**COMMISSION OF ARCHITECTURAL REVIEW
STAFF REPORT
July 22, 2014 Meeting**

2. **CAR No. 14-69** (E. Akarkarasu)

**720 N. 25th Street
Union Hill Old & Historic District**

Project Description: **Replace front porch columns and railing**

Exhibit A

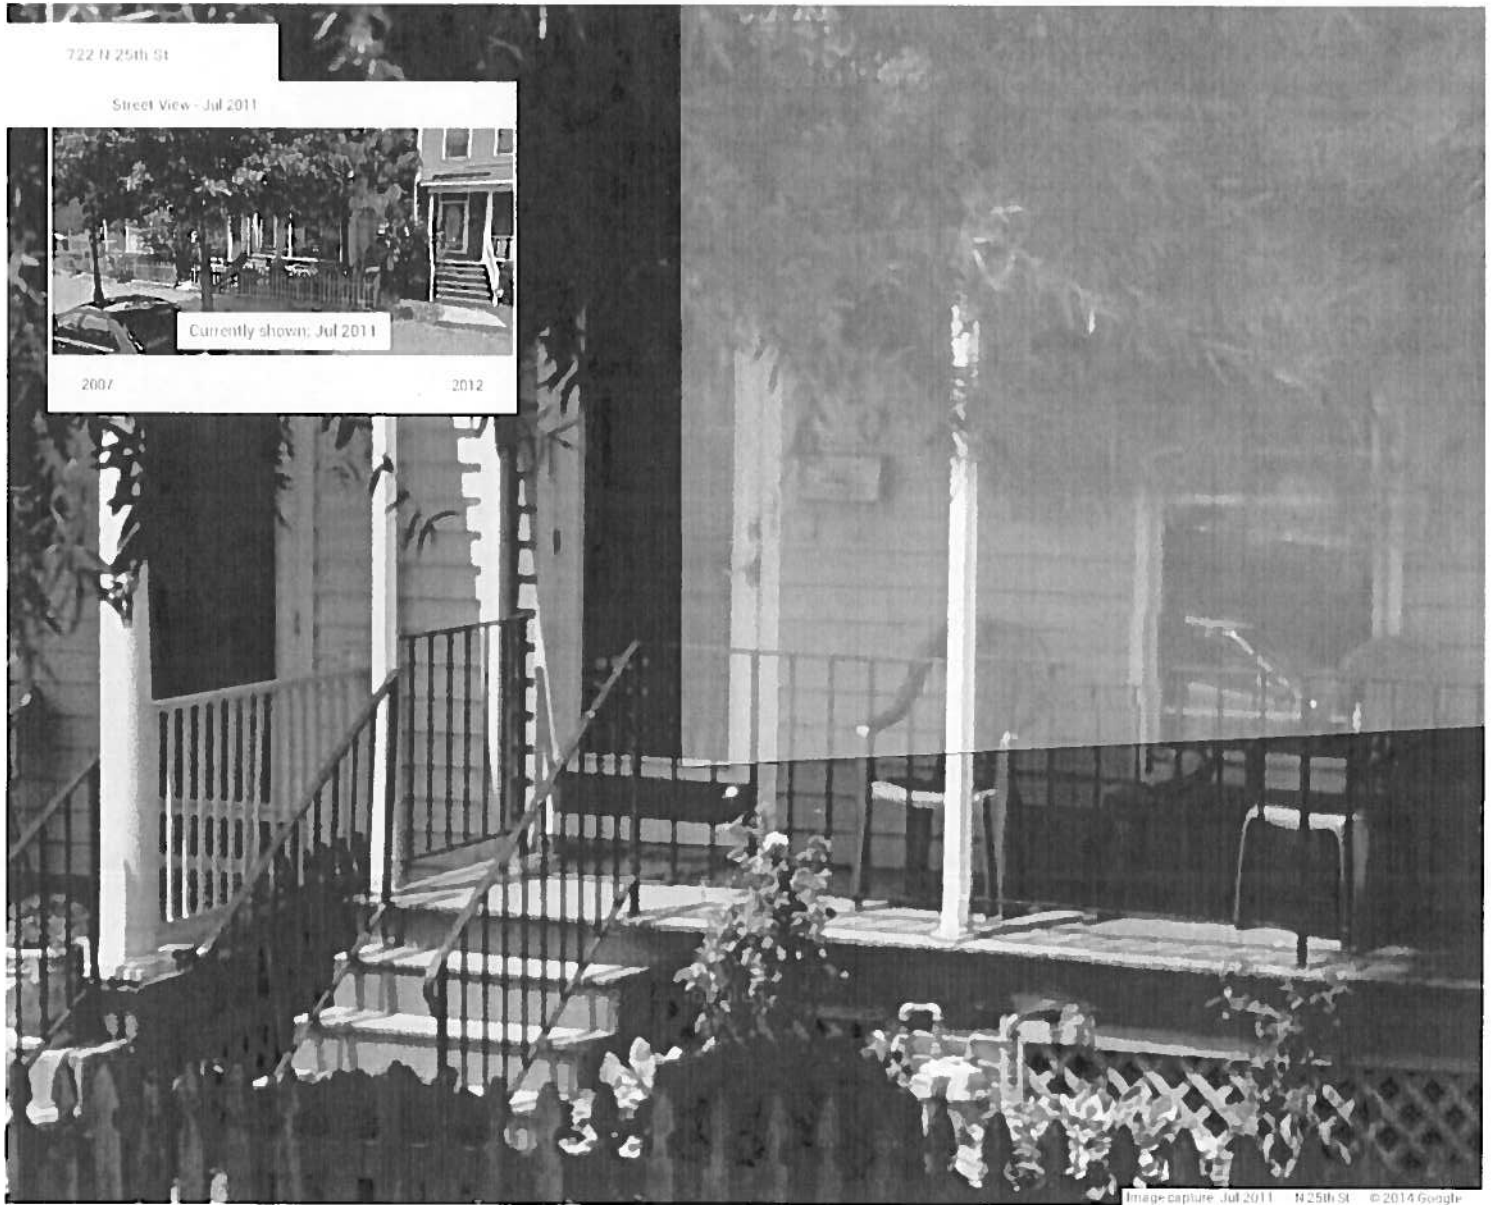
A photograph of the property from 2011 (see exhibit A) depicts the porch with slender, multi-sided posts and non-historic metal railings. The National Register nomination for Union Hill states that the porch had “octagonal, delicate thin columns with metal railings.” A 1977 survey photograph of the property shows the building with the slender columns and a railing with thin pickets that might or might not be turned (see exhibit B).

Staff recommends partial approval of the project. The Standards for Rehabilitation outlined on page 51 of the *Richmond Old and Historic District Handbook and Design Review Guidelines* note that original porch elements such as columns and other decorative features should be retained and repaired. The additional guidelines for the treatment of porches and entrances on page 61 of the *Guidelines* emphasize that porch elements are important in defining a building’s overall historic character, and that deteriorated porch features should be retained and repaired or replaced in kind. The previous metal railing at this property was not historic, and as the pickets resemble those depicted in the 1977 survey photograph, staff recommends that the applicant be allowed to retain the new railing system. The new turned posts do not appear to match the appearance of the earlier porch posts. If the Commission can confirm that octagonal porch posts were likely original to the property, staff recommends that the applicant replace the existing posts with ones that match the originals.
